SUBJECT: Withdraw of the November 16, 2015 Application for Modification, AND Application for Modification with Additional Information for Section 404 Individual Permit and Section 401 Individual Water Quality Certification for the US-74 Monroe Connector/Bypass in Union and Mecklenburg Counties. STIP R-3329 and STIP R-2559, Division 10, Debit WBS Element 34533.1.TA1 in the amount of \$570.

Reference: US Army Corps of Engineers (USACE) 404 Permit issued May 8, 2015; Action ID: SAW-2009-00876
NC Division of Water Resources (NCDWR) 401 Water Quality Certification Permit issued March 6, 2015; NCDWR Project No. 02-0672 V3

The North Carolina Department of Transportation (NCDOT) is in the process of constructing the Monroe Connector/Bypass, as authorized by the USACE and NCDWR as referenced above. NCDOT is requesting a permit modification for ten Permit Sites: 3, 5, 29, 30, 37, 46, 47, 48, 54, and 57, which are detailed below. Two other sites, 6 and 60, have revisions in jurisdictional areas that do not require a permit modification (see below).

Permit Site 54 (Revised Permit Drawings 213 and 214 of 267):

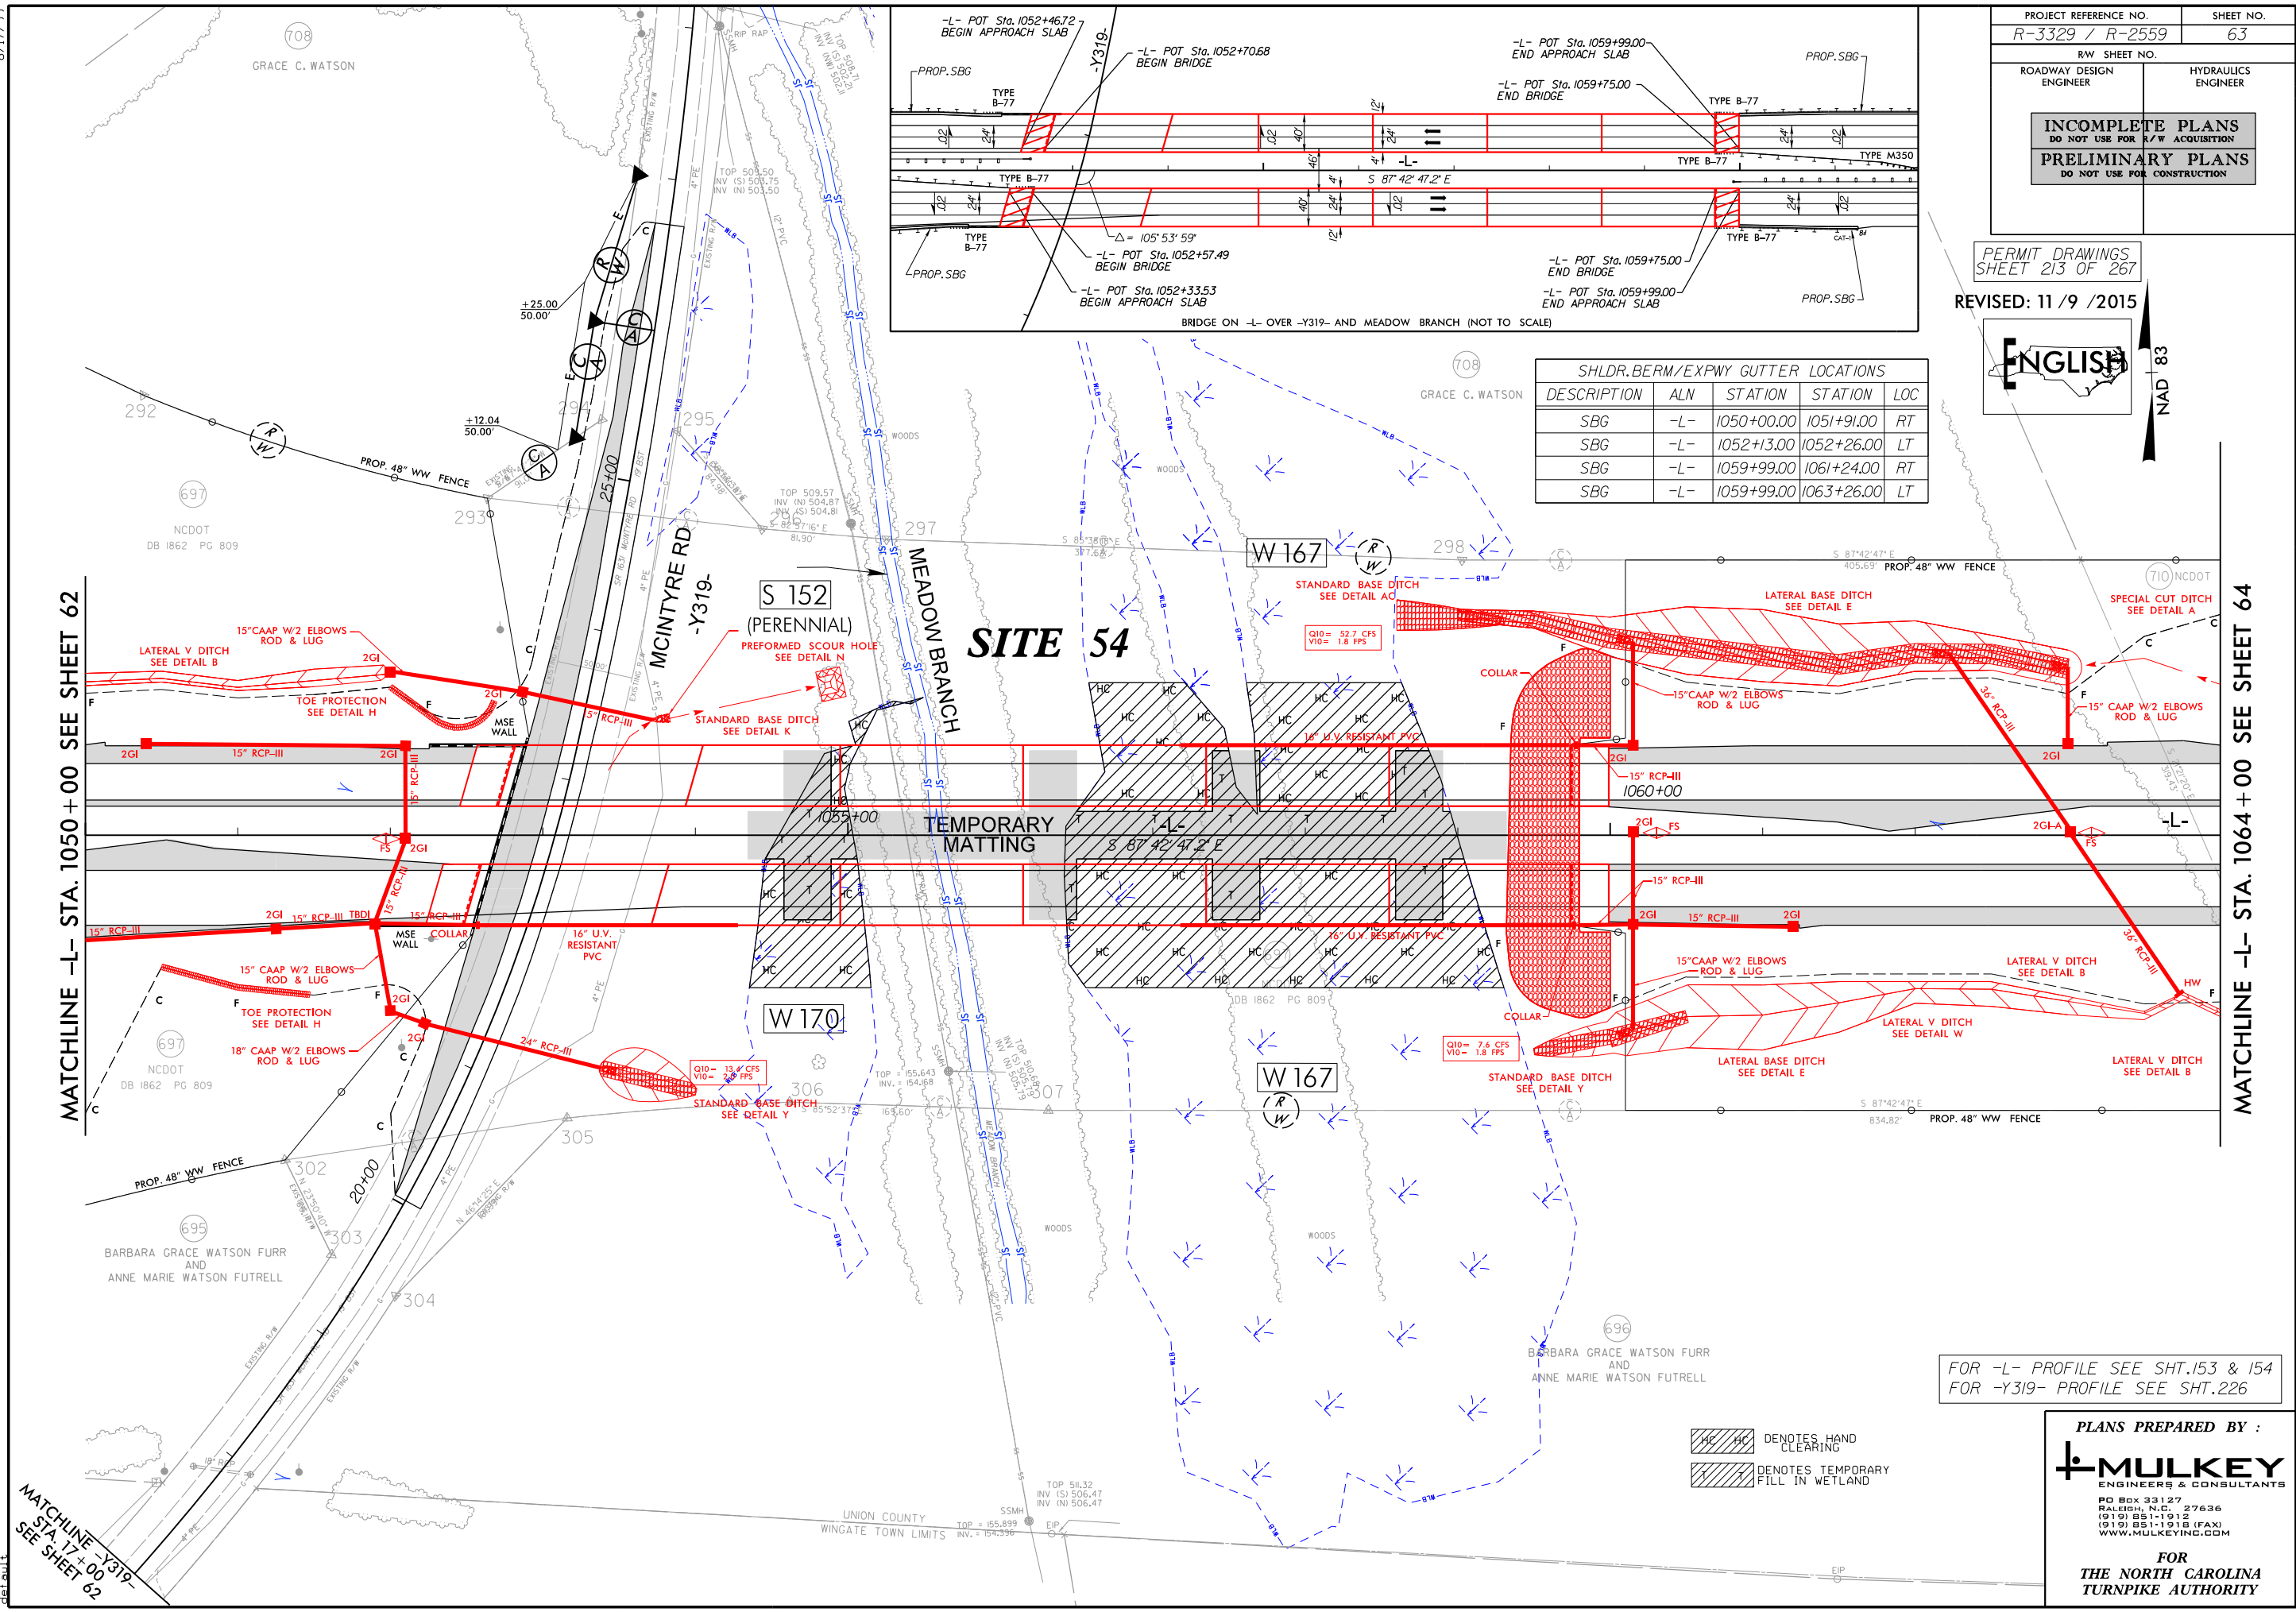
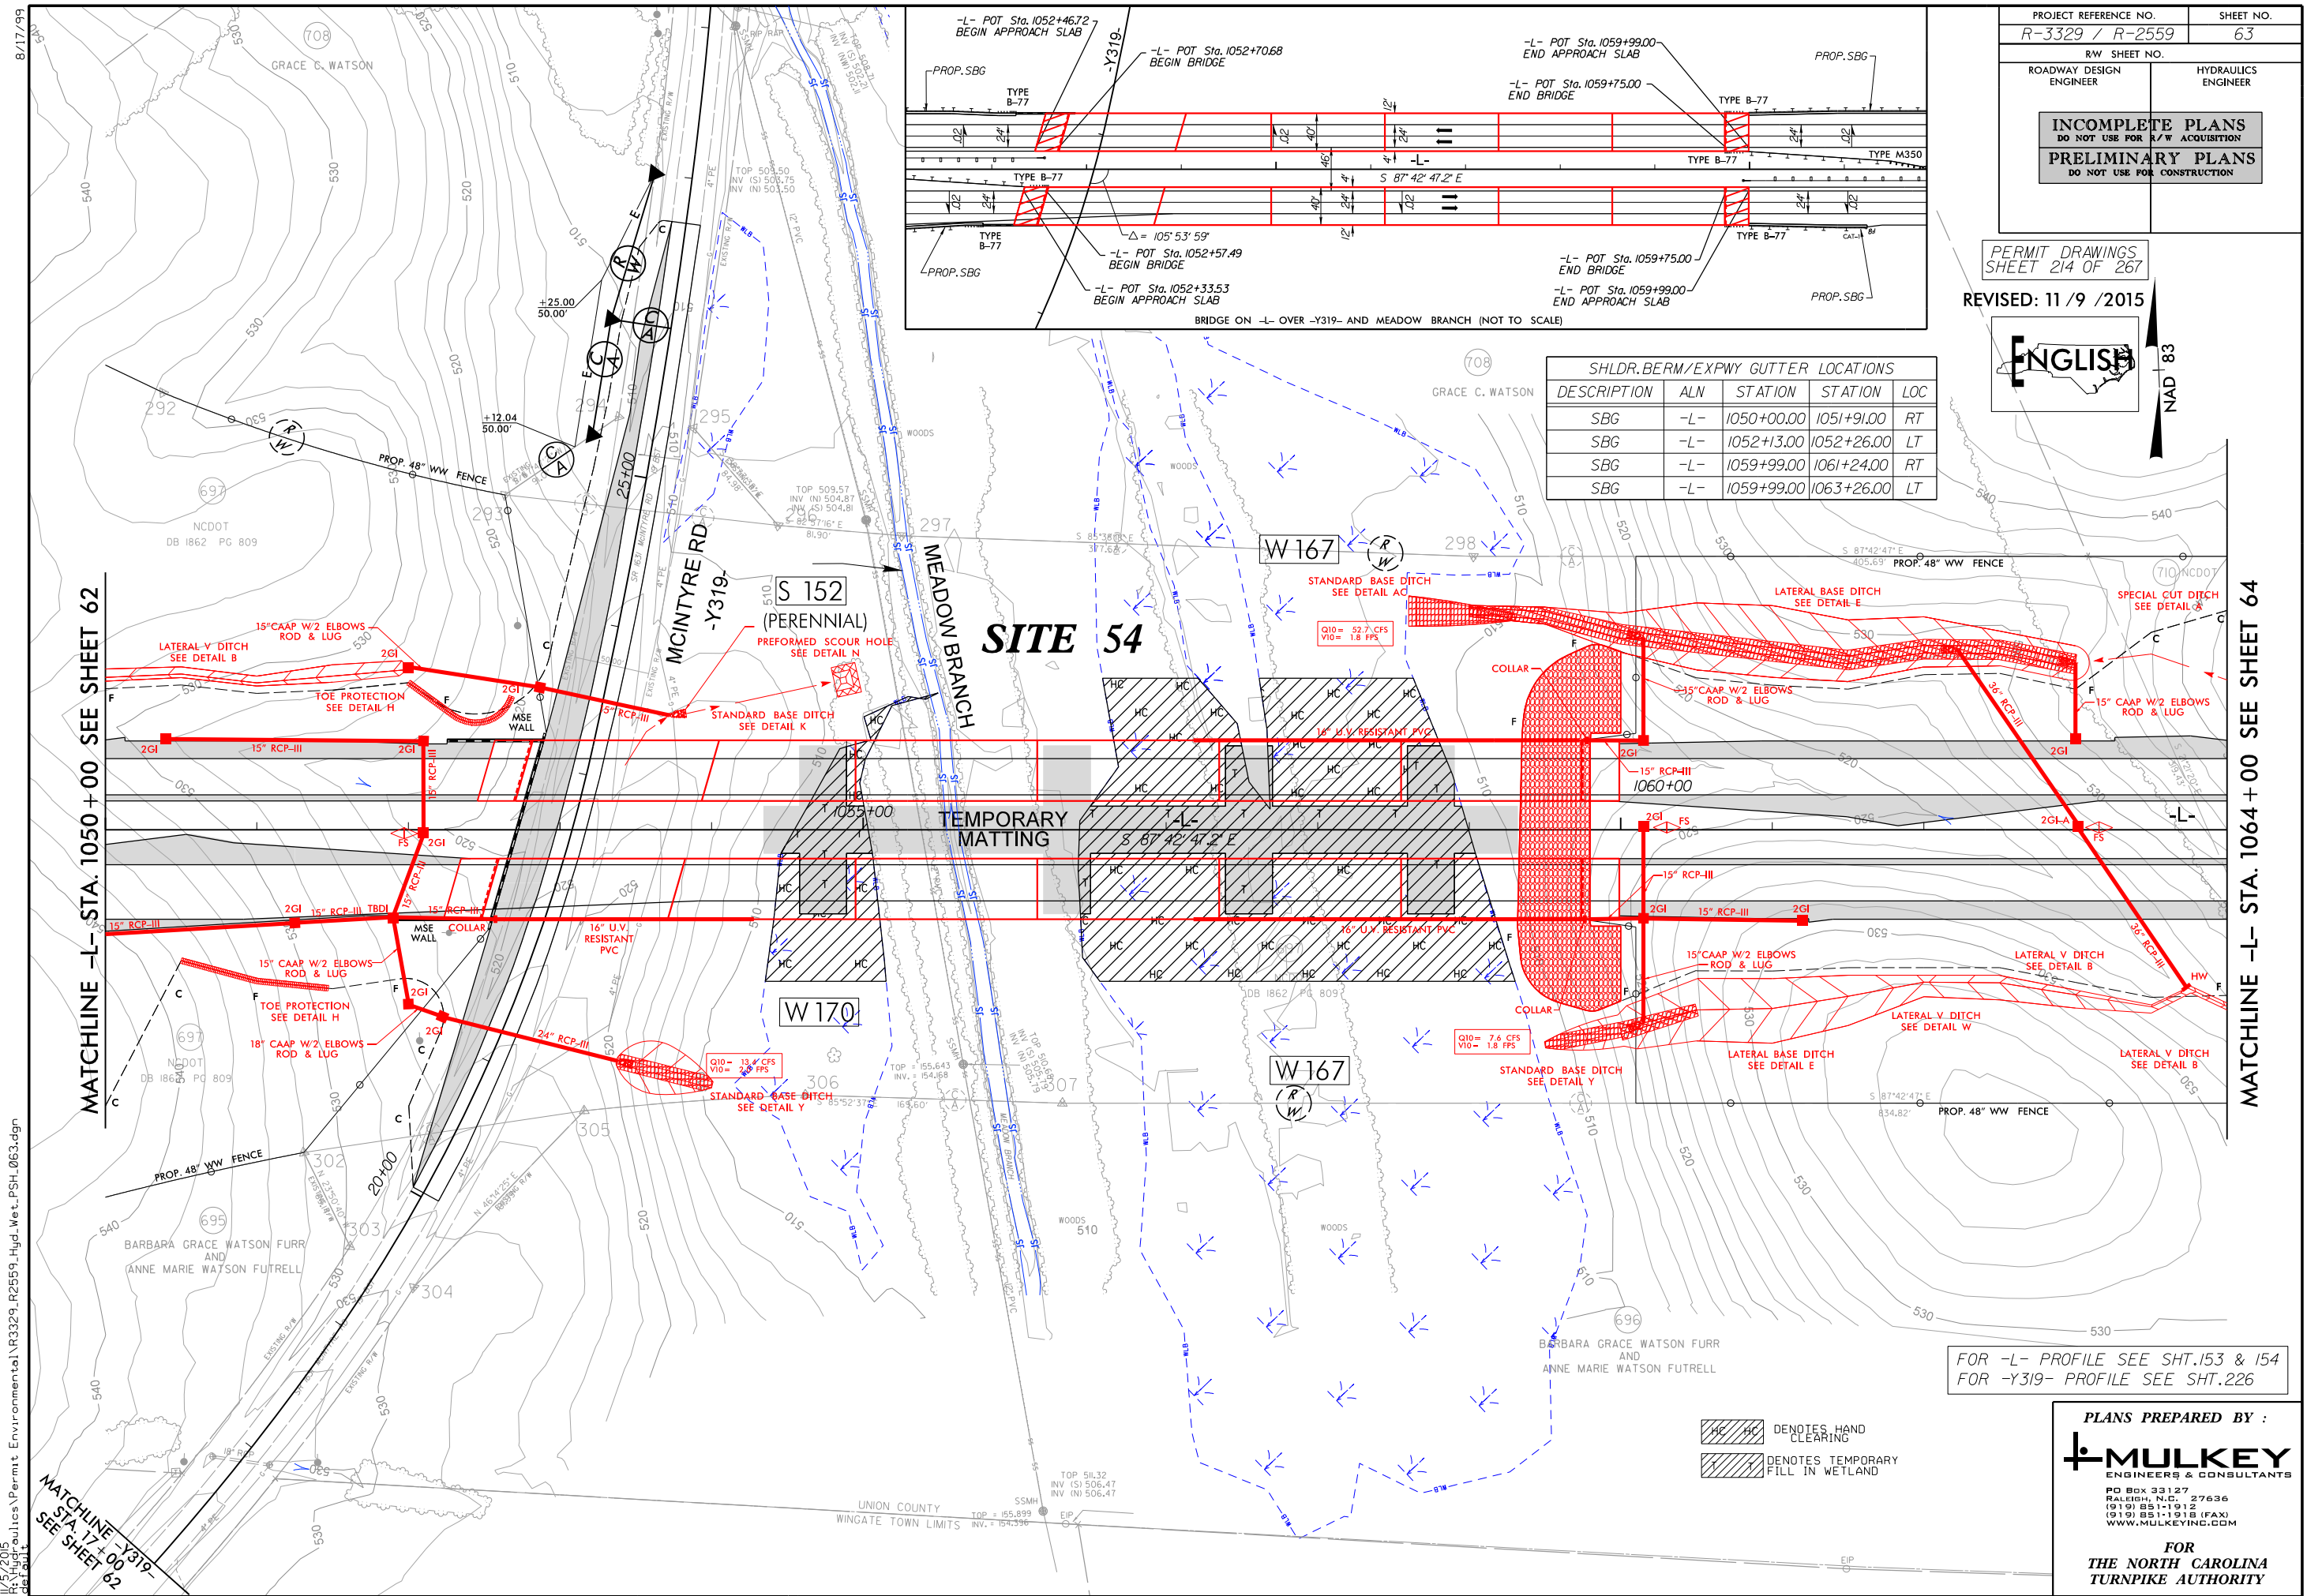
As noted in our correspondence on October 26, 2015, Site 54 is the crossing of Meadow Branch and the associated high quality wetland. As initially permitted, it was anticipated that it would be necessary to have 2 temporary work pads - along either side of the bridge - with work fingers extending towards the middle. However, taking the bridge design, access, and sensitive environmental conditions into consideration, the bridges can be constructed from a single work pad between the two bridges with the work fingers extending outwards. This minimization will **reduce the temporary impacts by 0.15 acre, from 0.52 to 0.37 acre.** The areas previously impacted by the work pads, will now only be impacted by hand clearing. This **increases the hand clearing at Site 54 by 0.15 acre, from 0.78 to 0.93 acre.** Permanent fill will remain the same (0.01 acre).
